**SOIL, GEOLOGY, GEOLOGIC HAZARD,
AND WASTEWATER STUDY
ARVIDSON SUBDIVISION
2310 WAKONDA WAY
MONUMENT, COLORADO**

September 14, 2017

Joseph E. Goode
President

please add EPC project
number to the cover of this
document

SCS MAP ARVIDSON SUBDIVISION 2310 WAKONDA WAY MONUMENT, CO. FOR: JENNA AND MATTHEW ARVIDSON			
DRAWN: LLL	DATE: 9/12/17	CHECKED:	DATE:

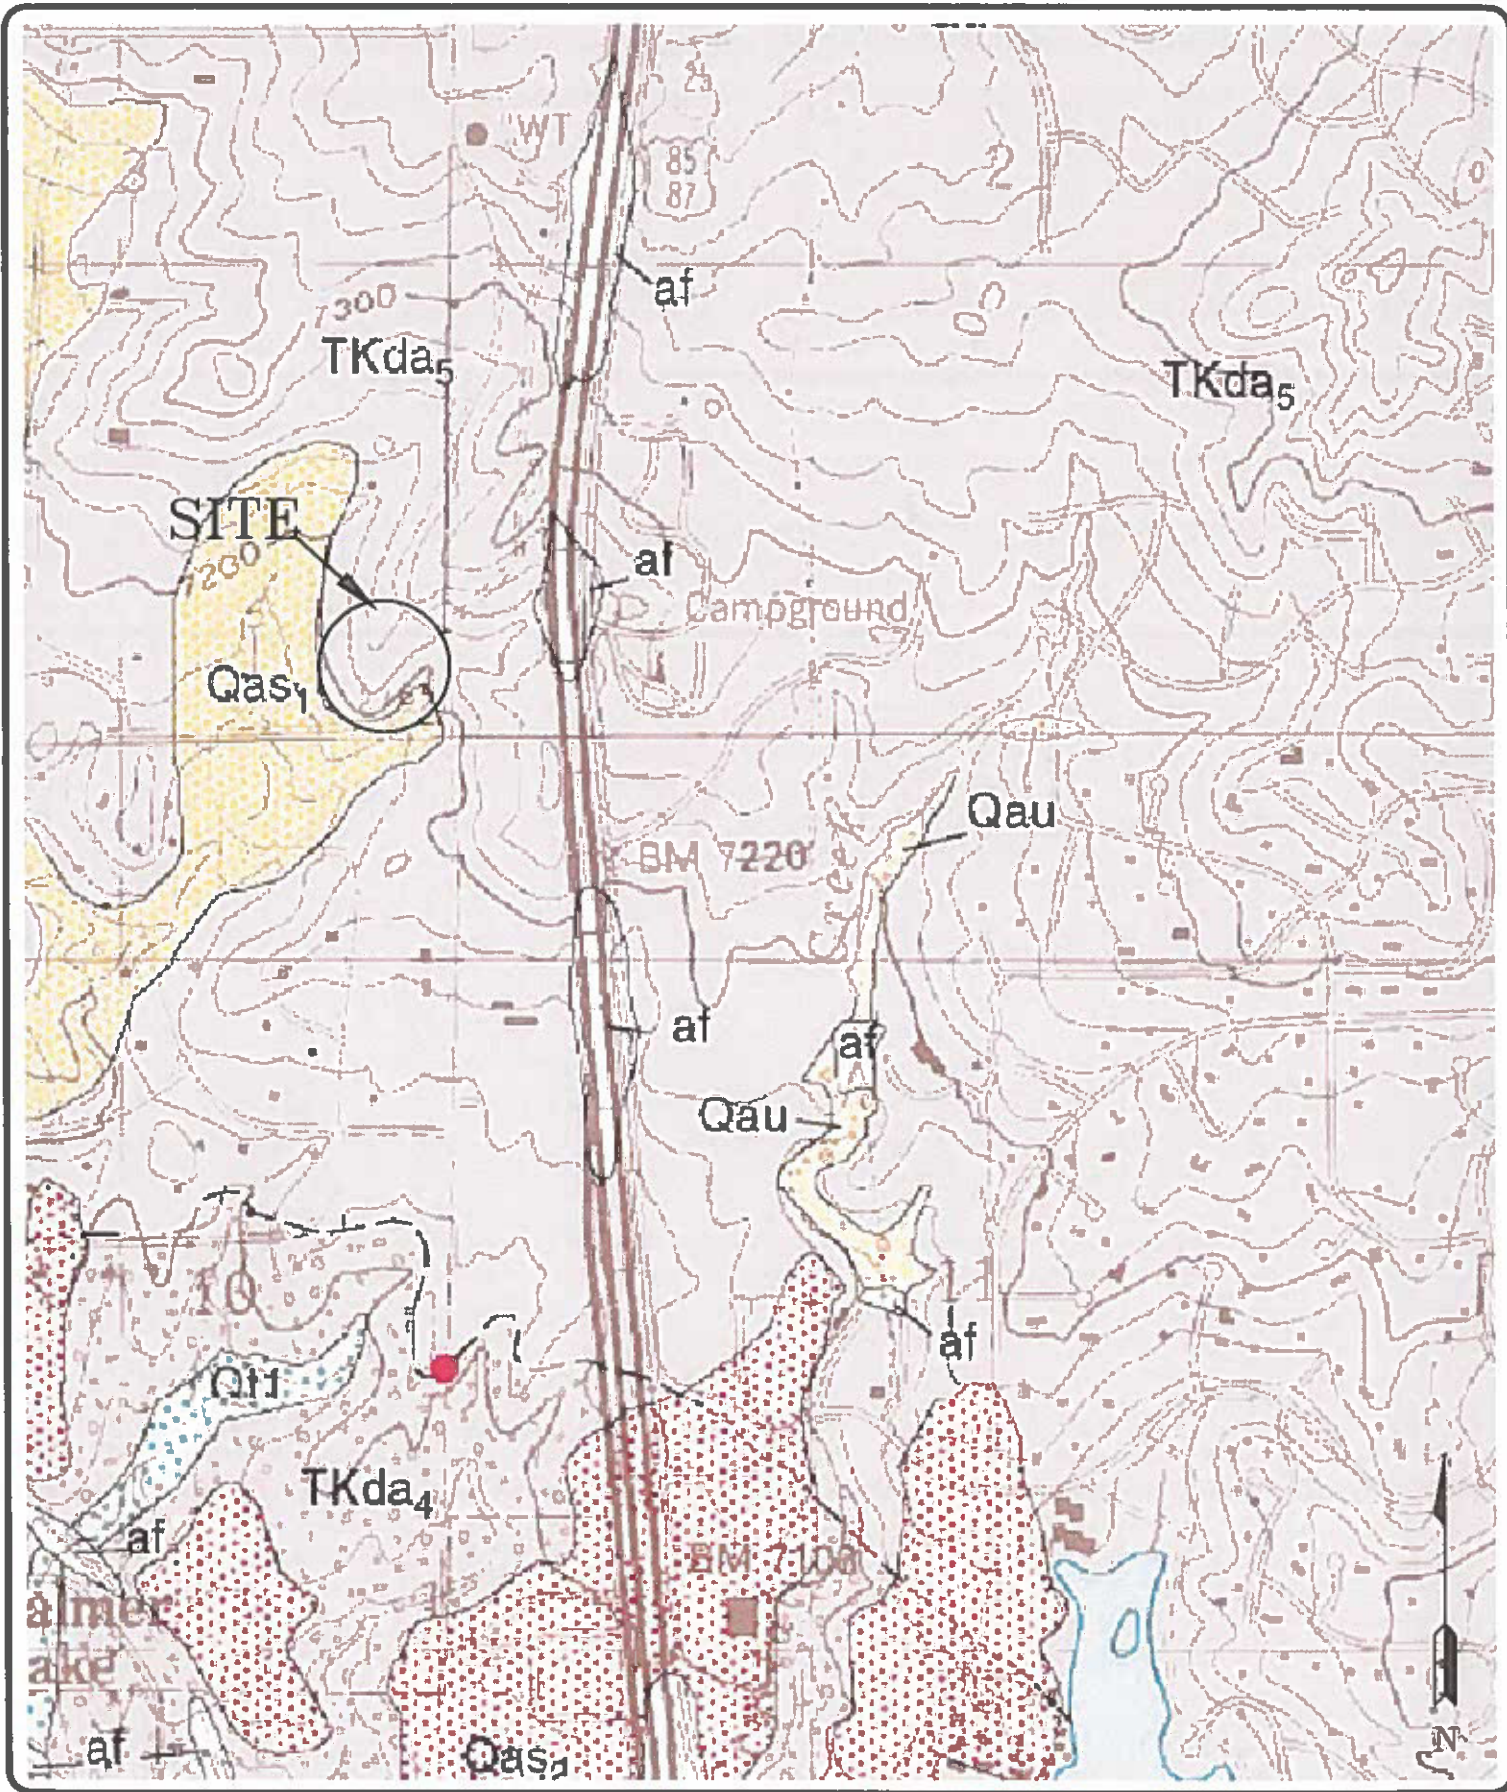
Please enlarge all text. None of it is readable.

GEOLOGY/ENGINEERING GEOLOGY MAP
ARVIDSON SUBDIVISION
 2310 WAKONADA WAY
 MONUMENT, CO.
 FOR: JENNA AND MATTHEW ARVIDSON

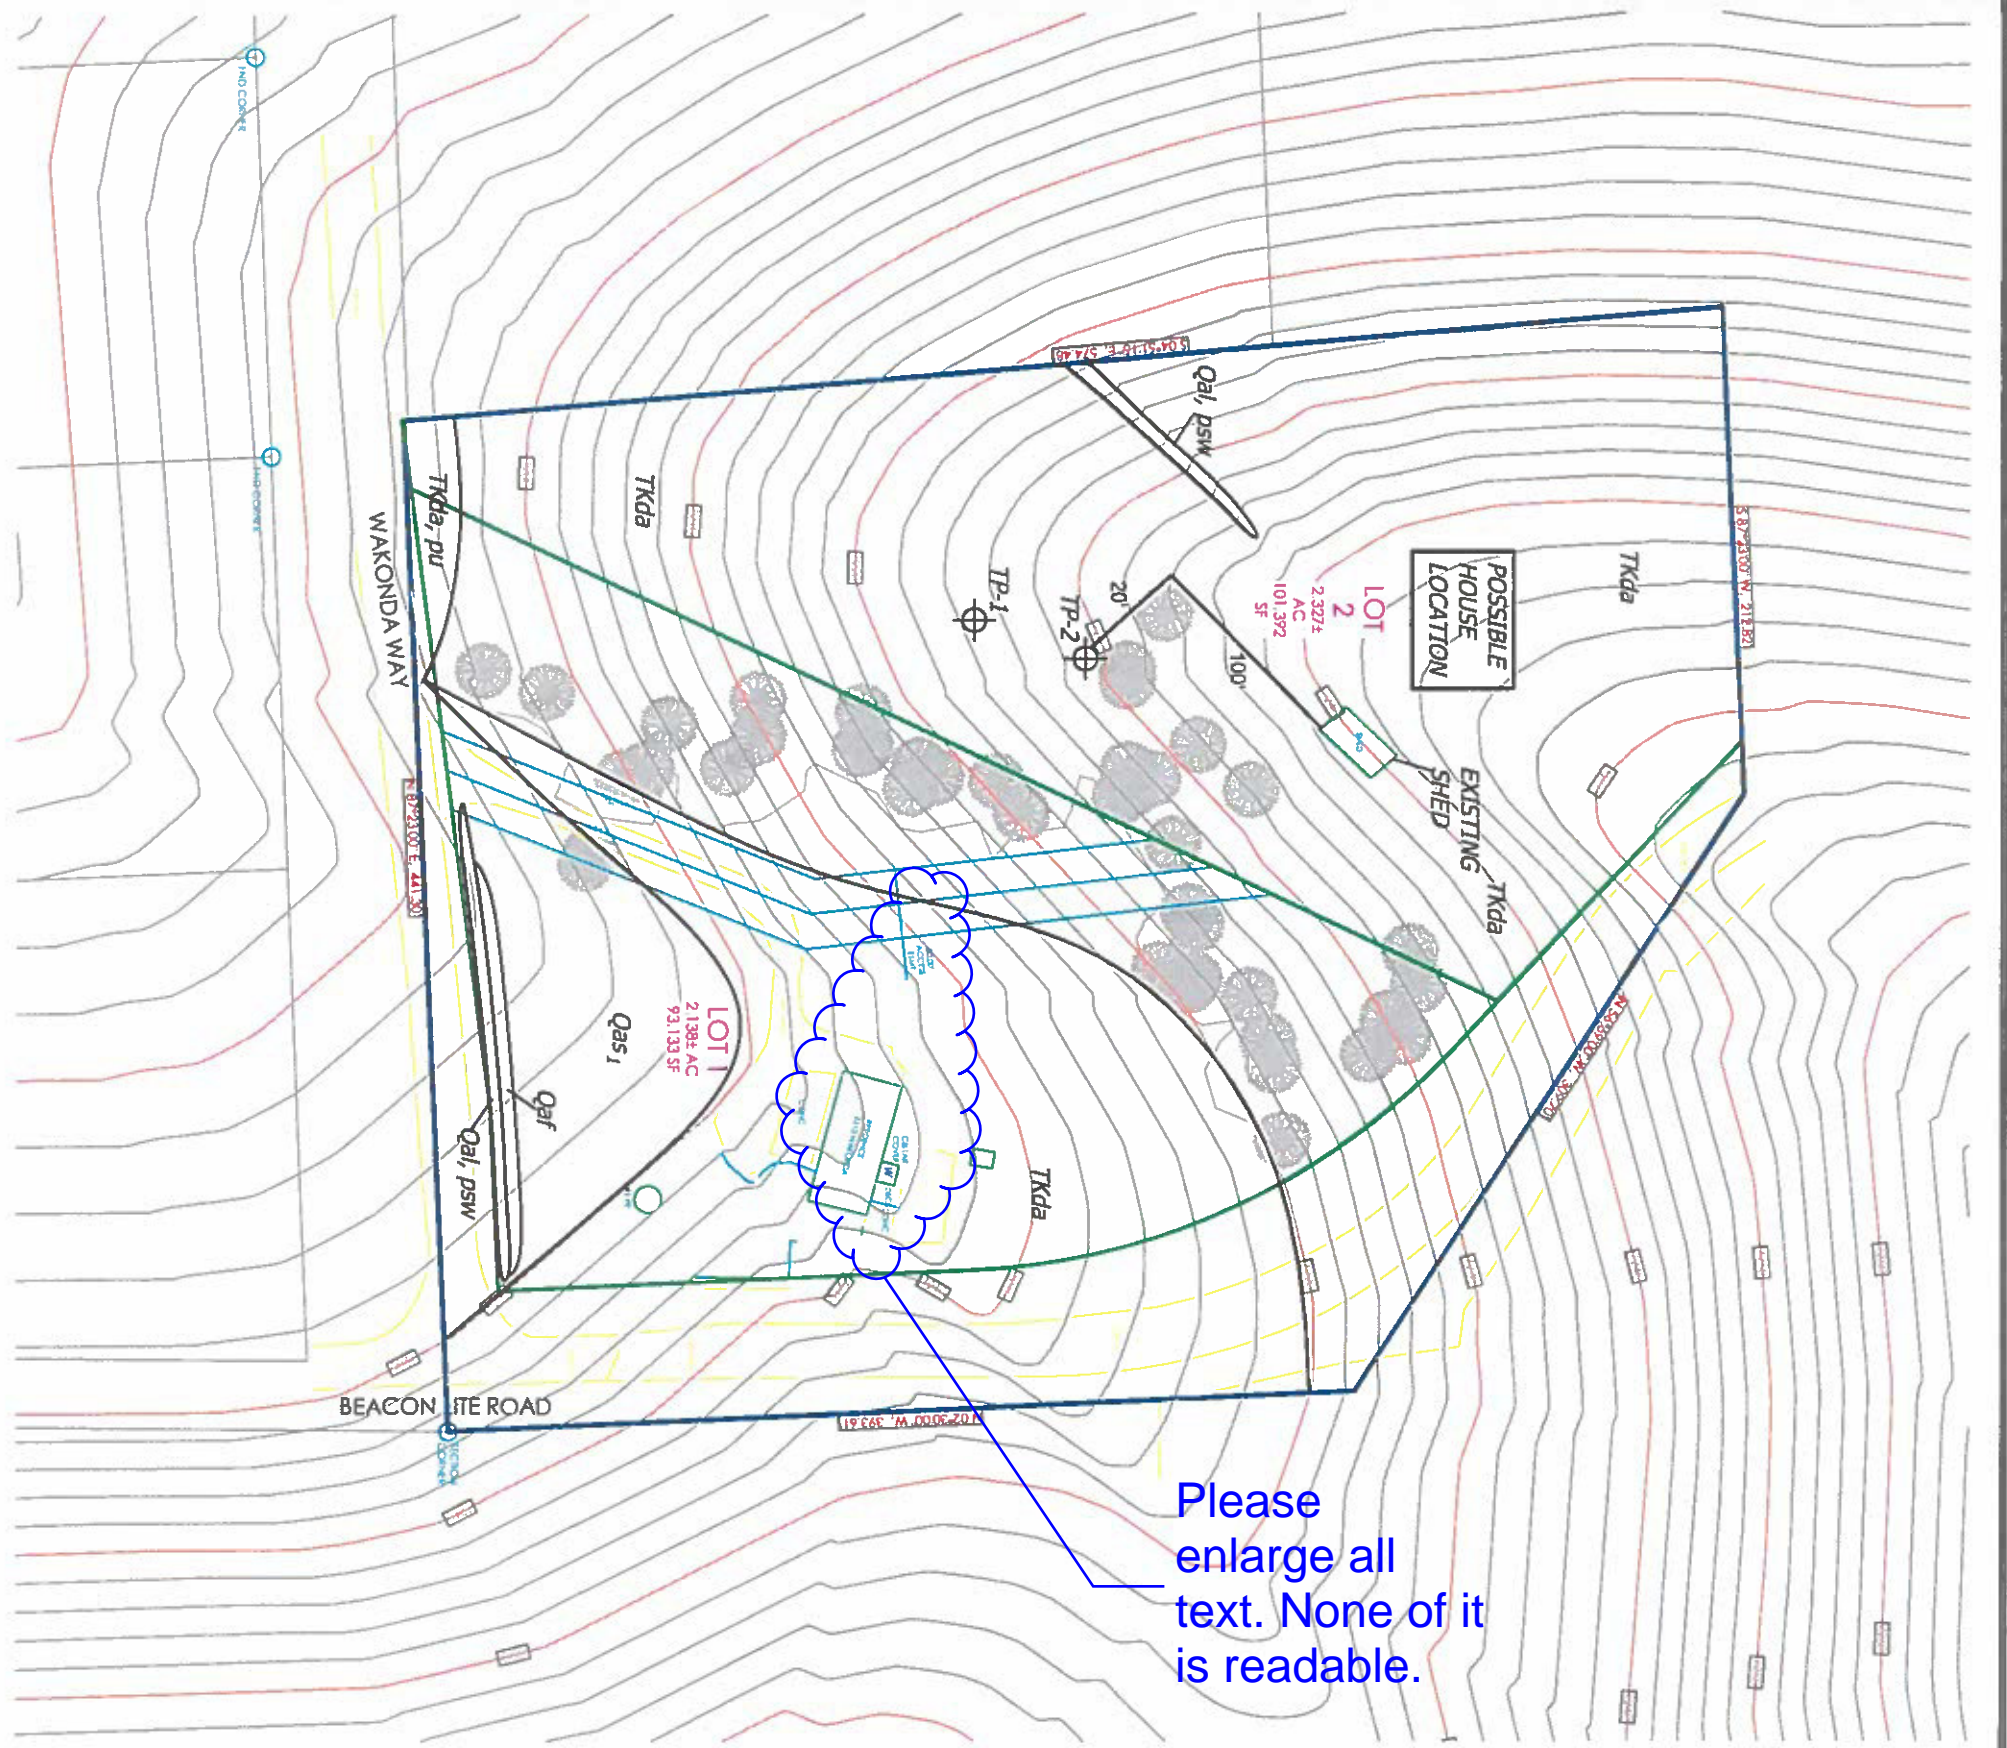
only soil types are shown,
please show other
constraints as listed in the
report.

please call out
these areas
on one of the
exhibits

Please call out
extents on
one of the
exhibits.

OWTS SUITABILITY MAP
 ARVIDSON SUBDIVISION
 2310 WAKONADA WAY
 MONUMENT, CO.
 FOR: JENNA AND MATTHEW ARVIDSON

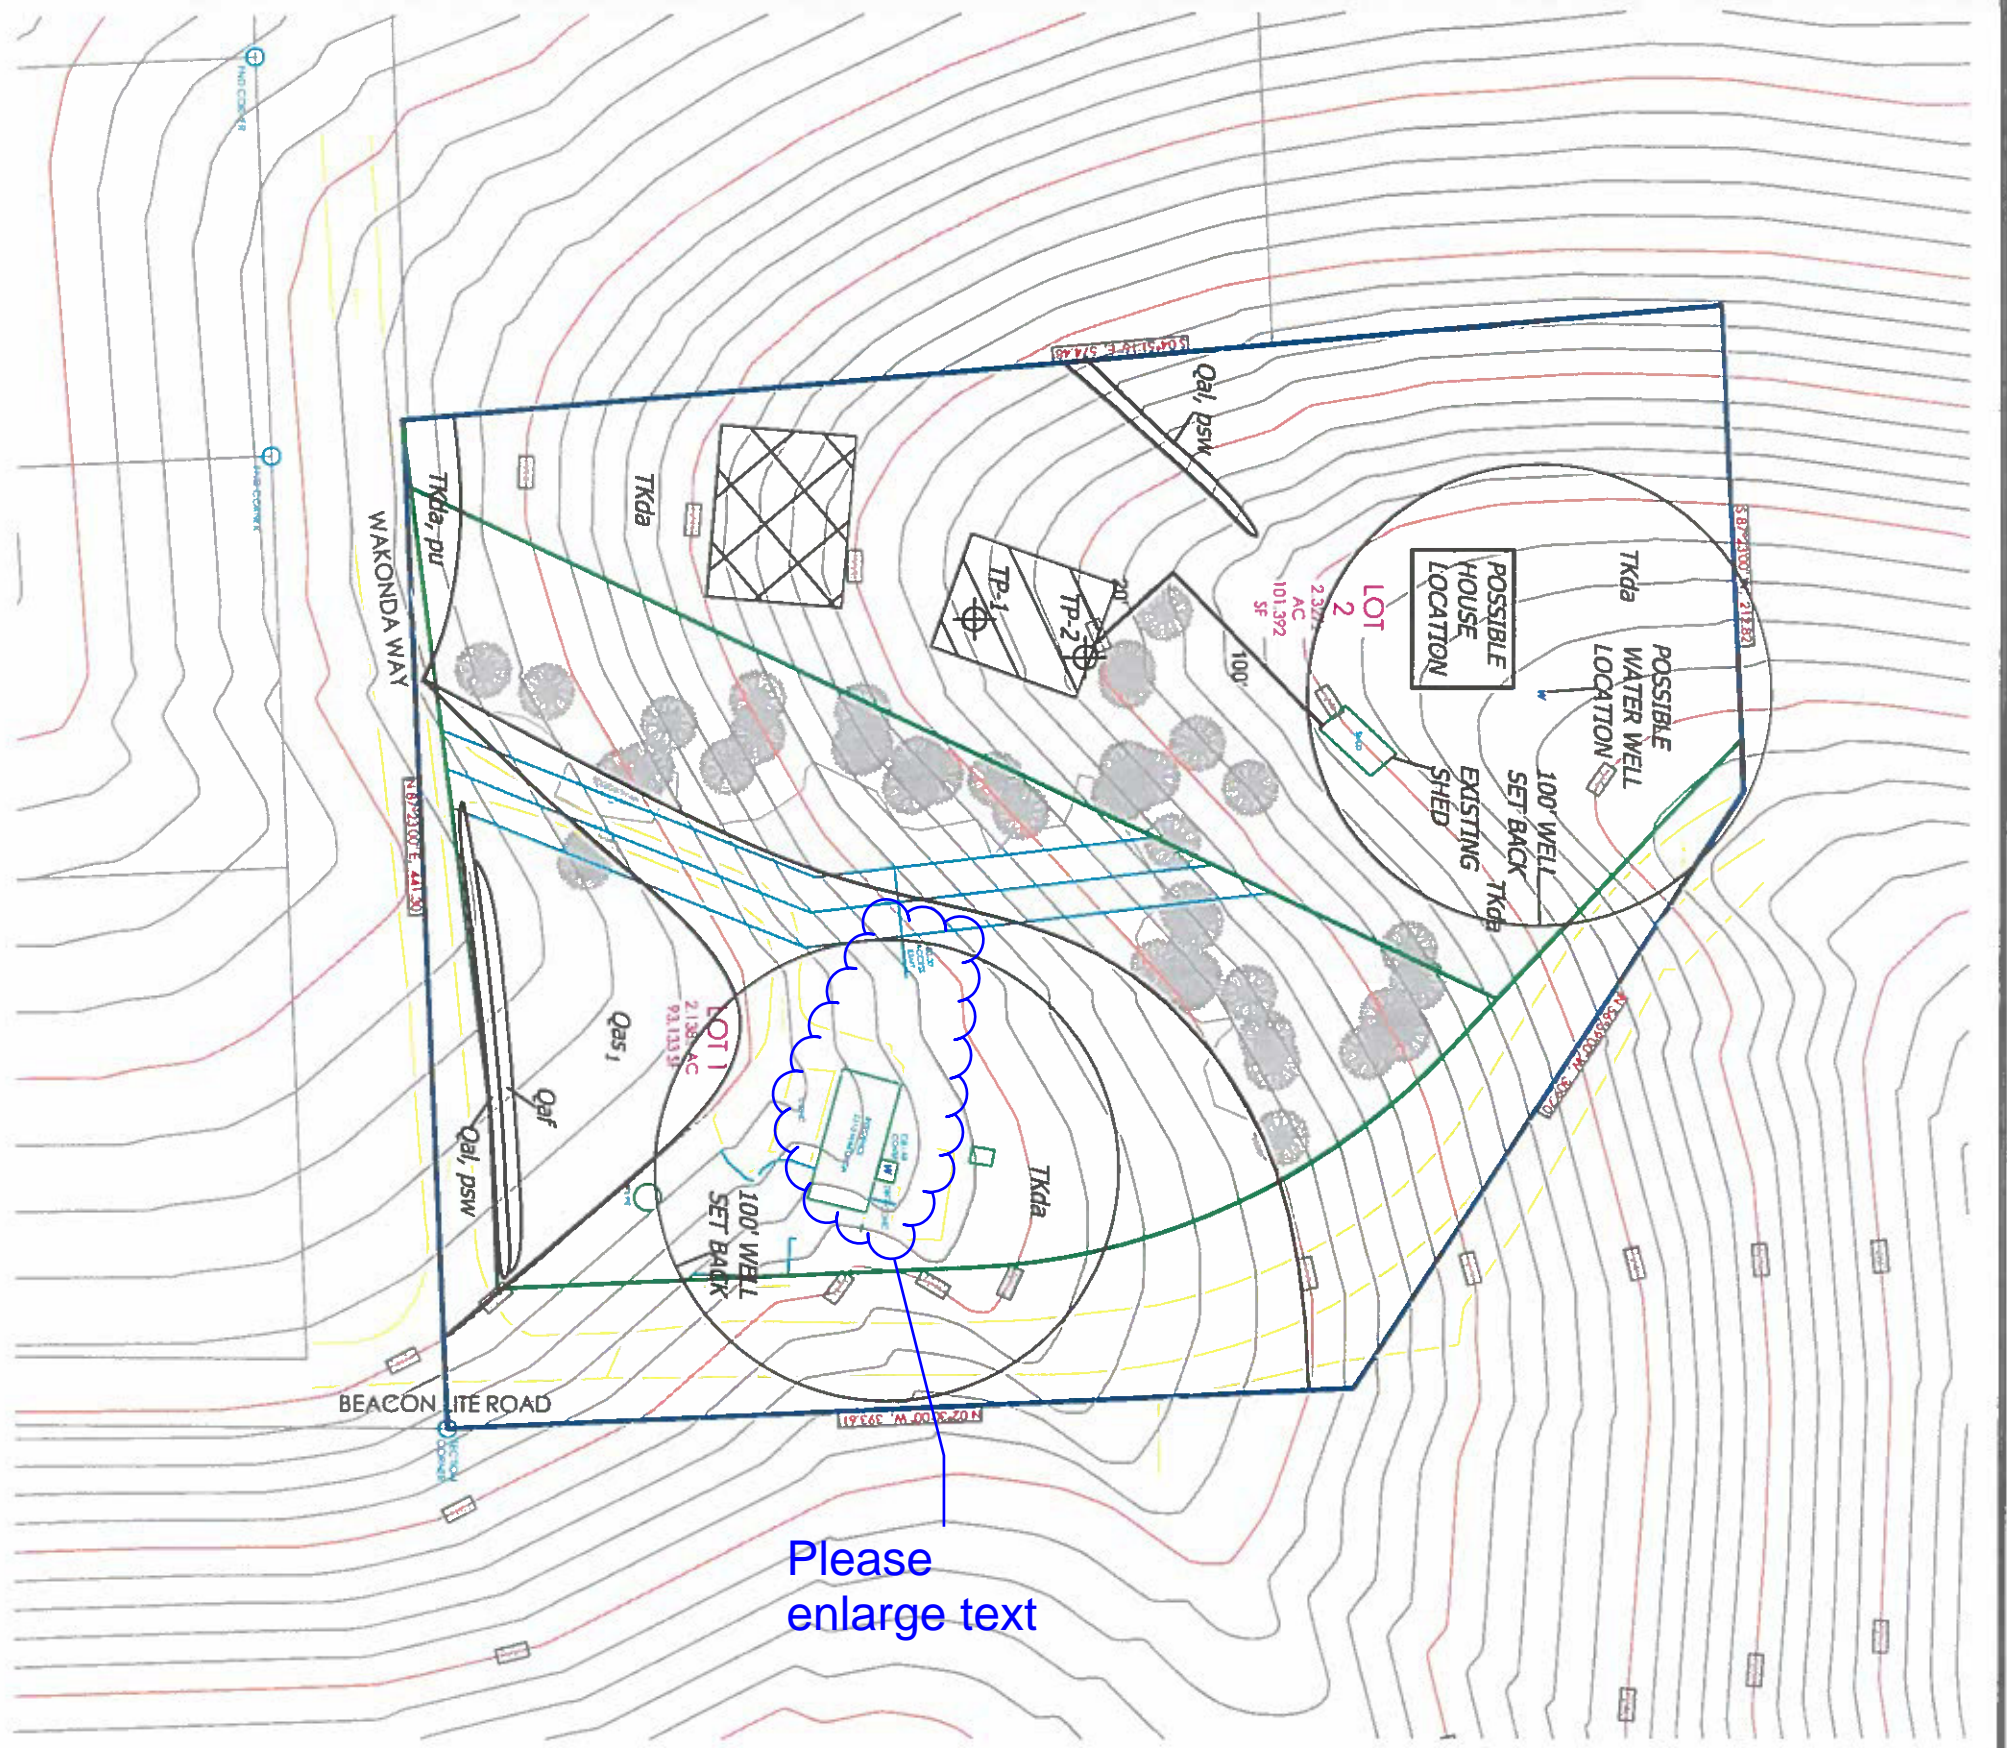
please show
on the exhibit.

Please enlarge text
